Bonney Forge Corp SO 18913

REVISED: 12/19/12 BY J.T.L TO
SHOW DUCT VC-430 MACHINE

Project: Bonney Forge Corp
Drawing: Duct Layout
Date: 8-23-12 Drawn by: MDT
Sheet No: 1 OF 1

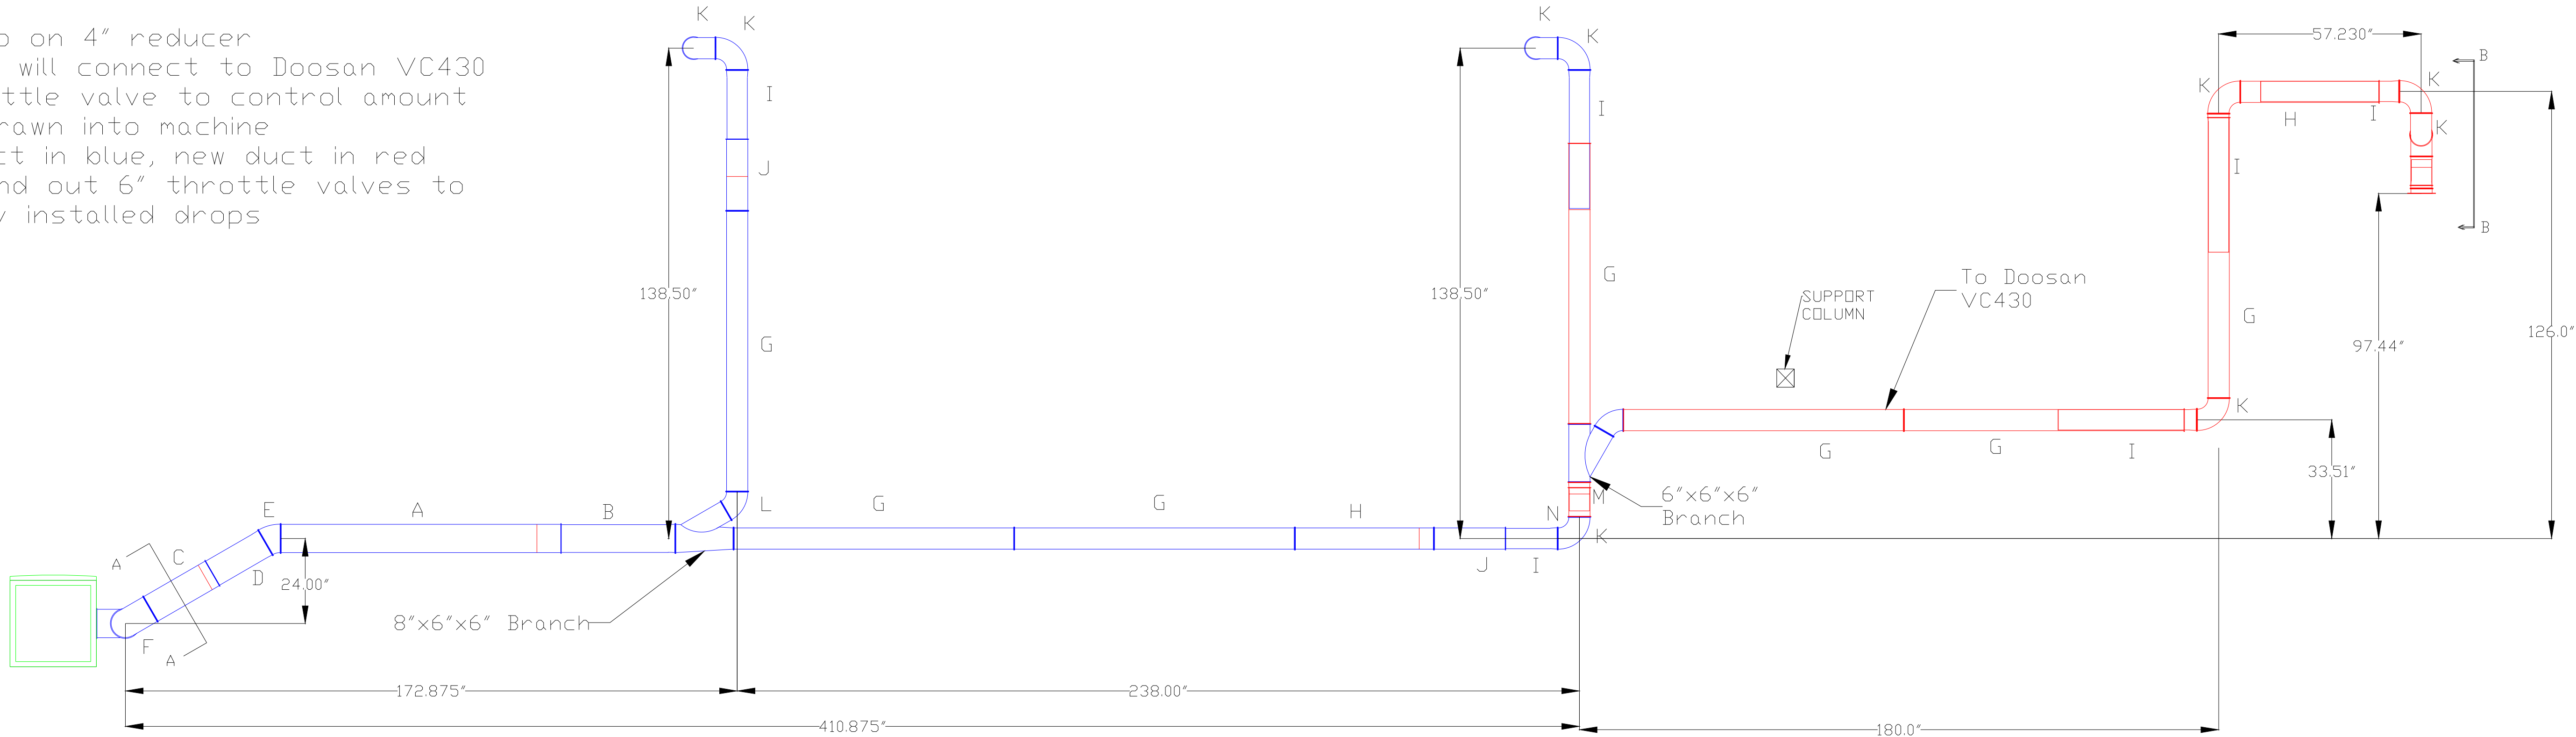
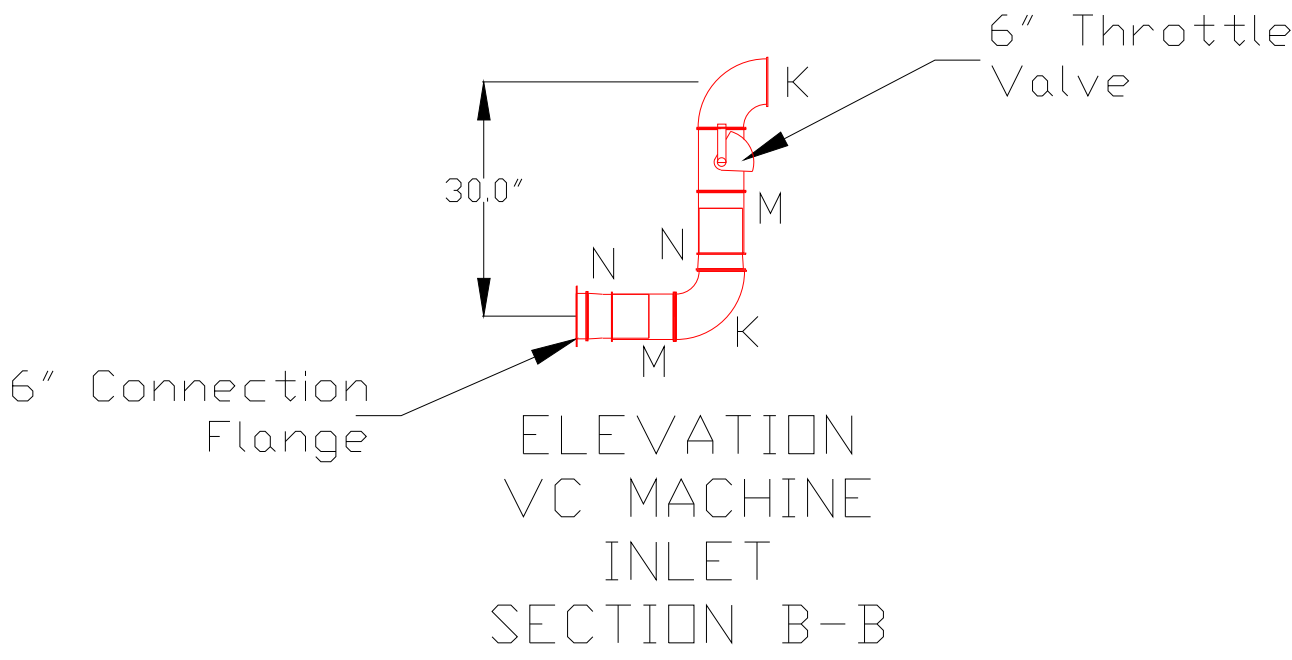
1. End cap on 4" reducer
2. Branch will connect to Doosan VC430 with throttle valve to control amount of CFM drawn into machine
3. Old duct in blue, new duct in red
4. Will send out 6" throttle valves to previously installed drops
